<b>Docket Number:</b>	09-AFC-05C
<b>Project Title:</b>	Abengoa Mojave Compliance
<b>TN #:</b>	253380
<b>Document Title:</b>	Mojave Solar Project Comments - Mojave Solar Pond's Liner Extension Project - Petition to Amend
<b>Description:</b>	N/A
<b>Filer:</b>	System
<b>Organization:</b>	Mojave Solar Project
<b>Submitter Role:</b>	Applicant Representative
<b>Submission Date:</b>	11/29/2023 1:32:57 PM
<b>Docketed Date:</b>	11/29/2023

# **Petition To Amend**

## **Pond's Liner Extension Project**

**Mojave Solar**

Scale: 1" = 80'	EVAPORATION PONDS BETA SITE LINER EXTENSION LIMITS	Plan No: Sheets: 2 Sheet No: 2 Plan No. Int:
--------------------	--	---

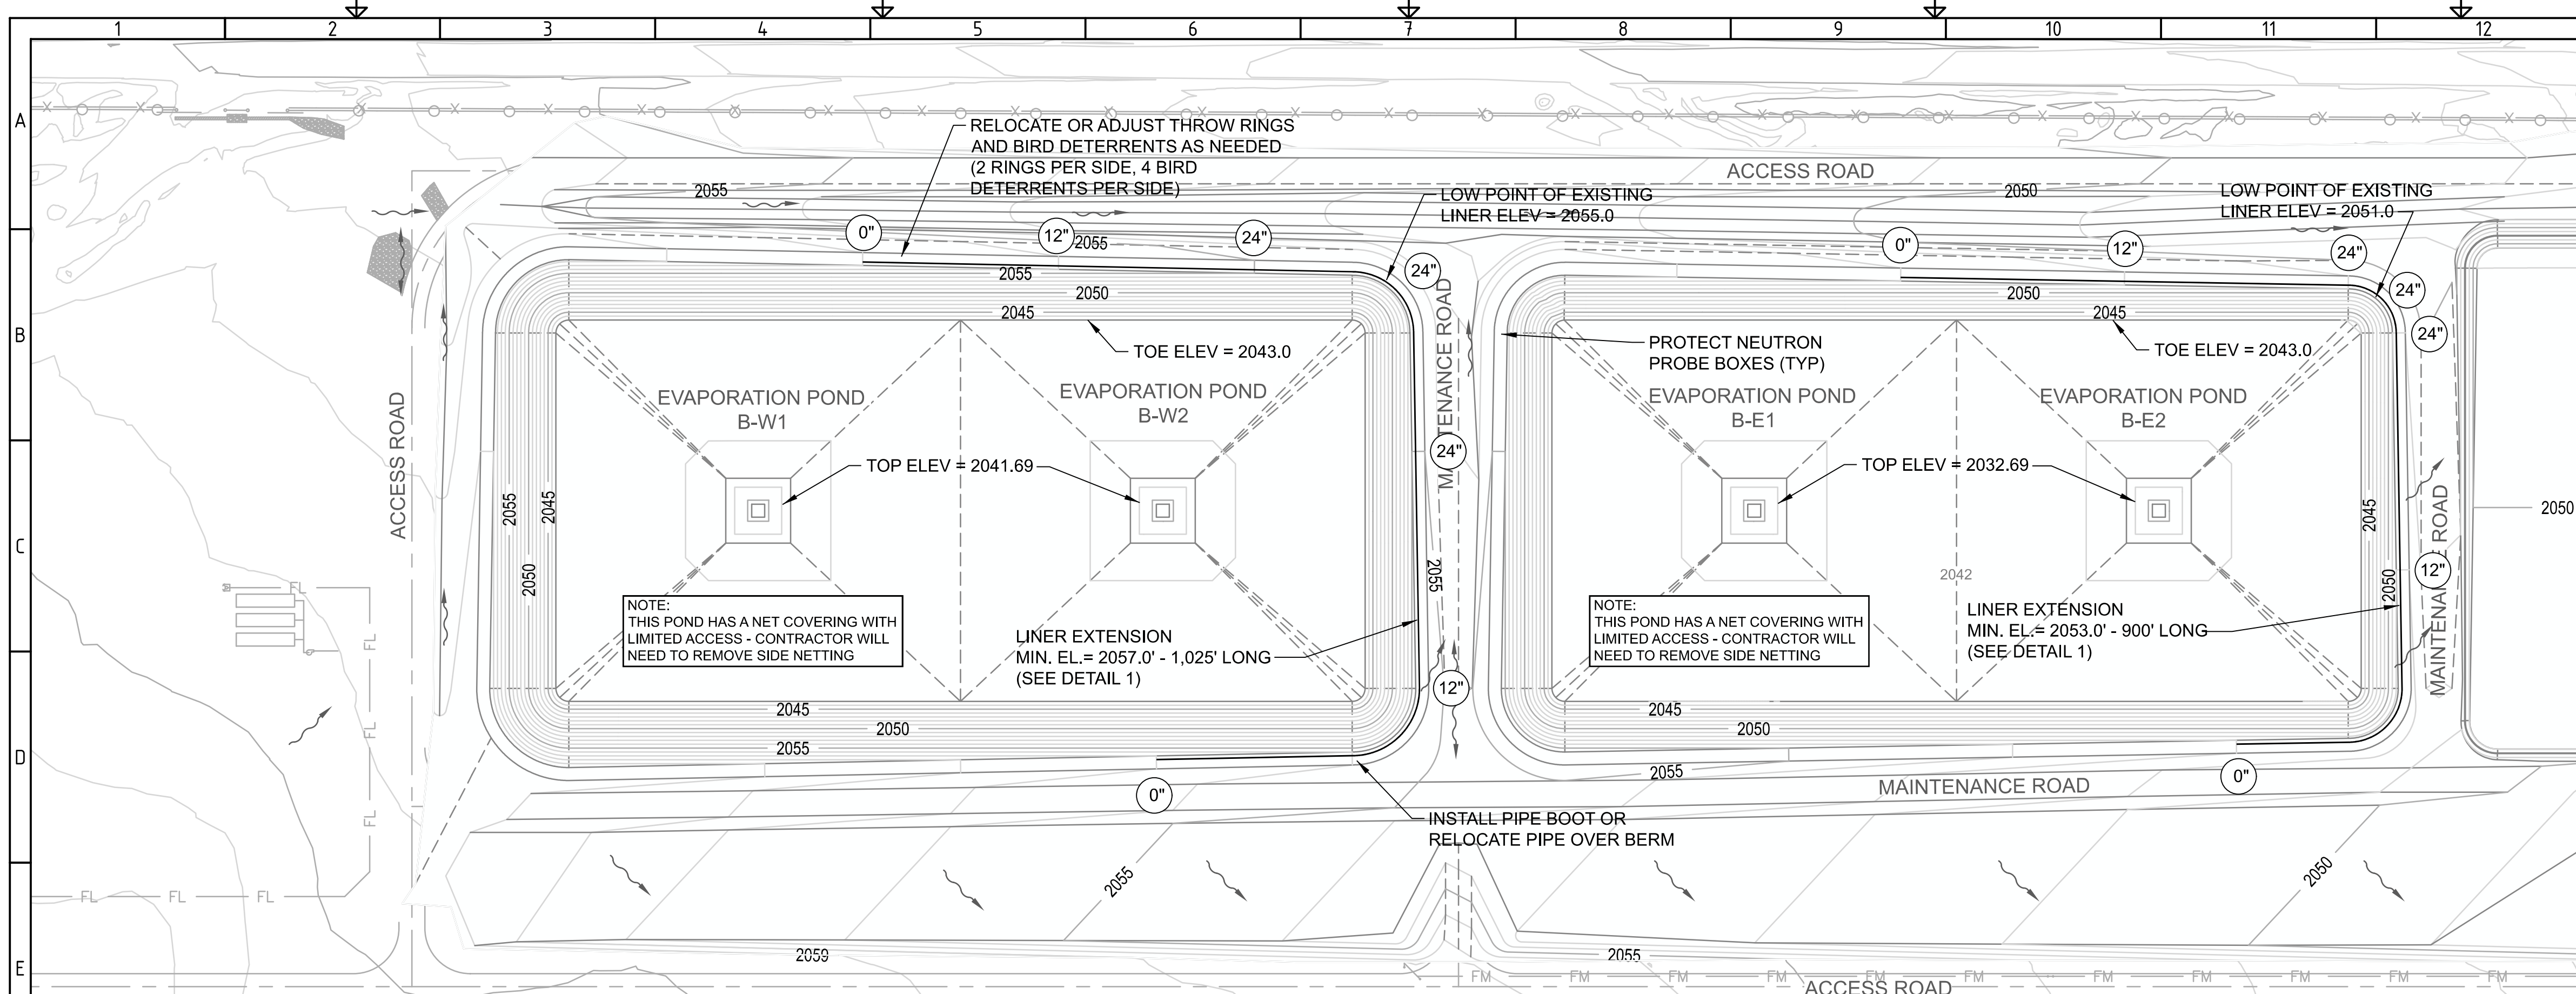
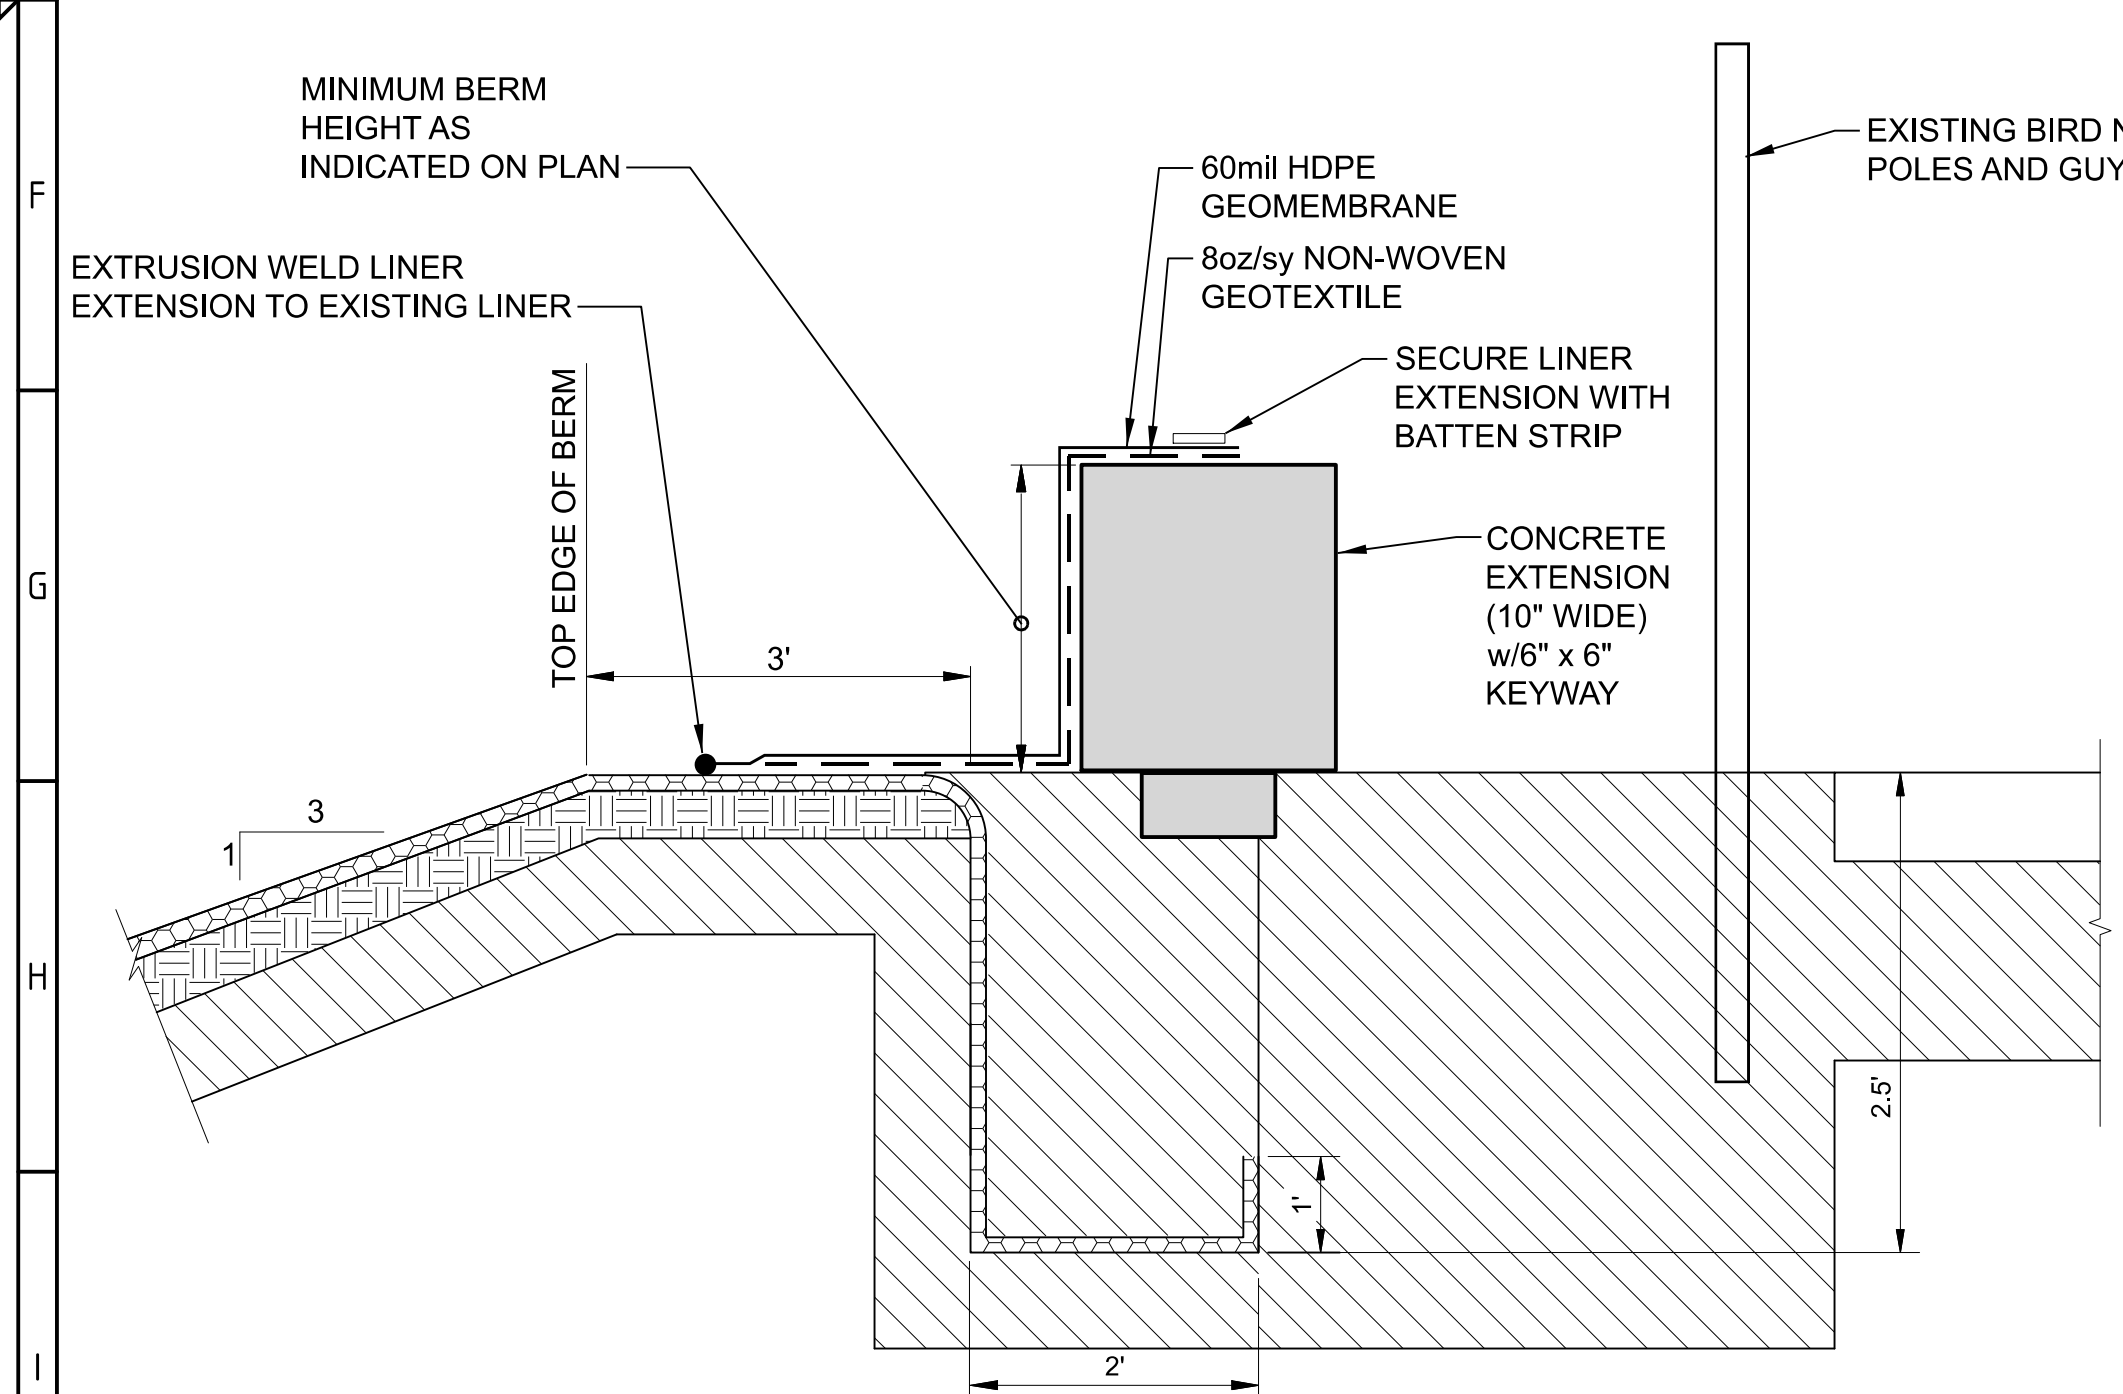
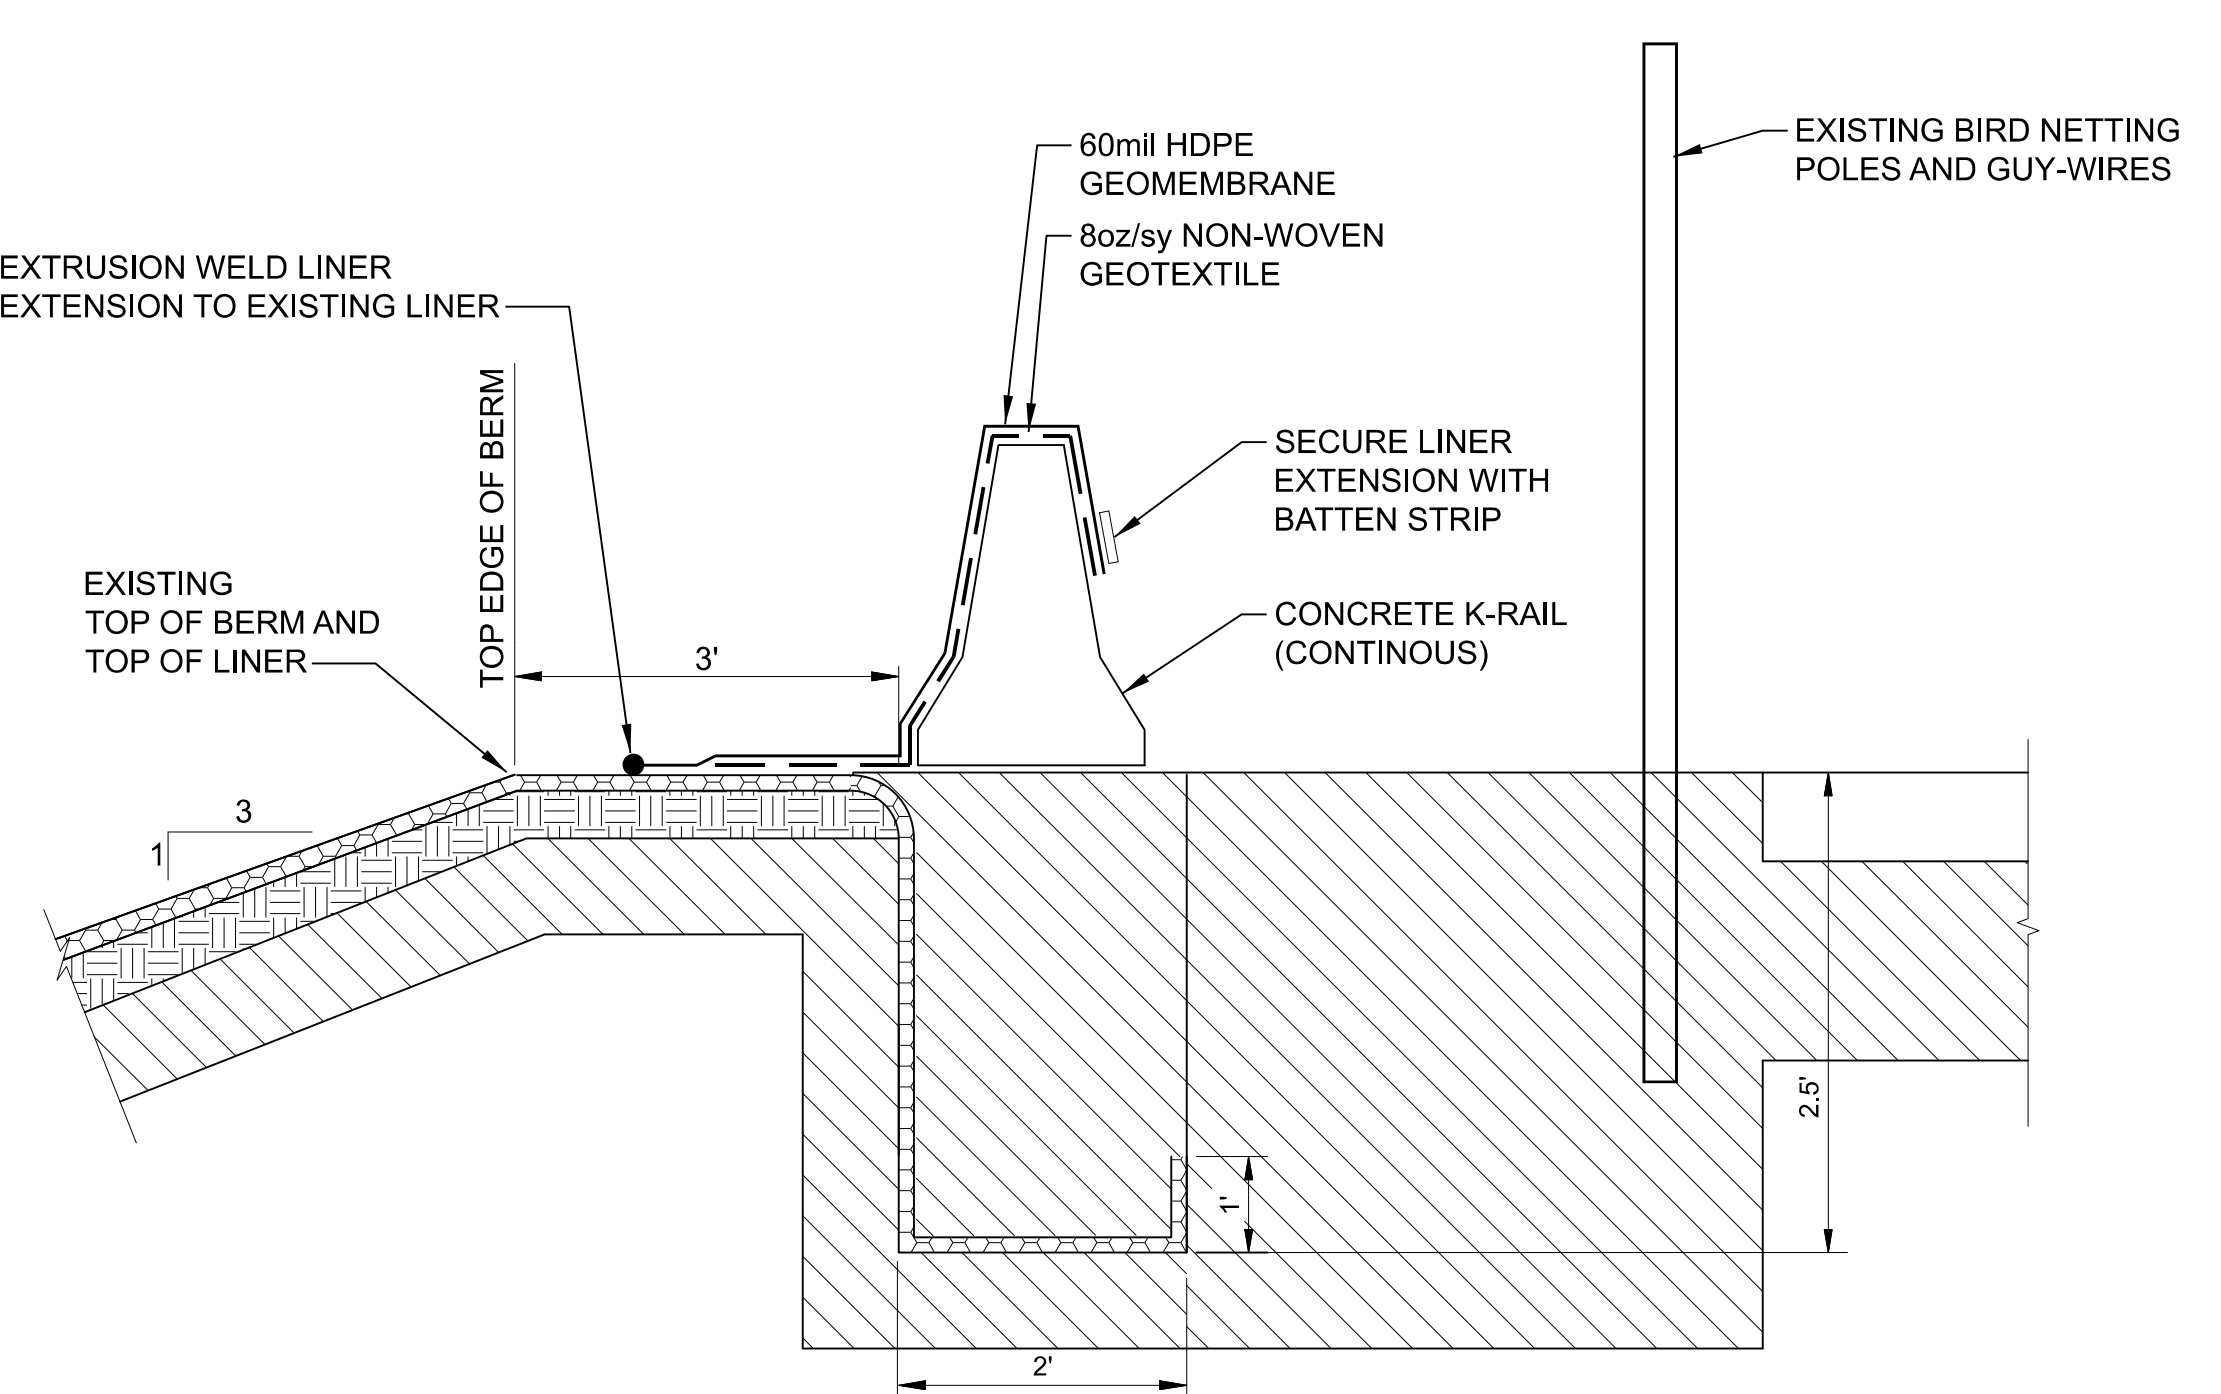
For the Beta ponds, bird netting is existing or in the process of being added over the ponds. The poles to suspend the cables/netting over the pond are offset from the edge of liner between 3 and 8 feet. Given the limited space, a conventional soil berm is difficult to construct. HAI recommends construction of a cast-in-place concrete stem wall/berm. The concrete wall can be formed between the existing liner anchor trench and the bird netting, concrete will be pumped to the form work from outside the pond fencing and netting. Once the concrete wall is constructed, the 60 mil HDPE geomembrane will be installed by extrusion welding the extension to the existing liner system and extending the liner up and onto the top of the wall. The geomembrane will be secured using a batten strip and anchor bolts. The extrusion welds would be non-destructively tested for leaks by use of the vacuum box test or similar method.

Based on the above, HAI has developed the design plans for construction of the liner extension for both the Alpha and Beta Ponds. Each pond is independent of the others and therefore, the liner extensions can be constructed individually or as a group depending on MSP's need and budget. The design plans are attached as Sheets 1 and 2. Appendix 10.1
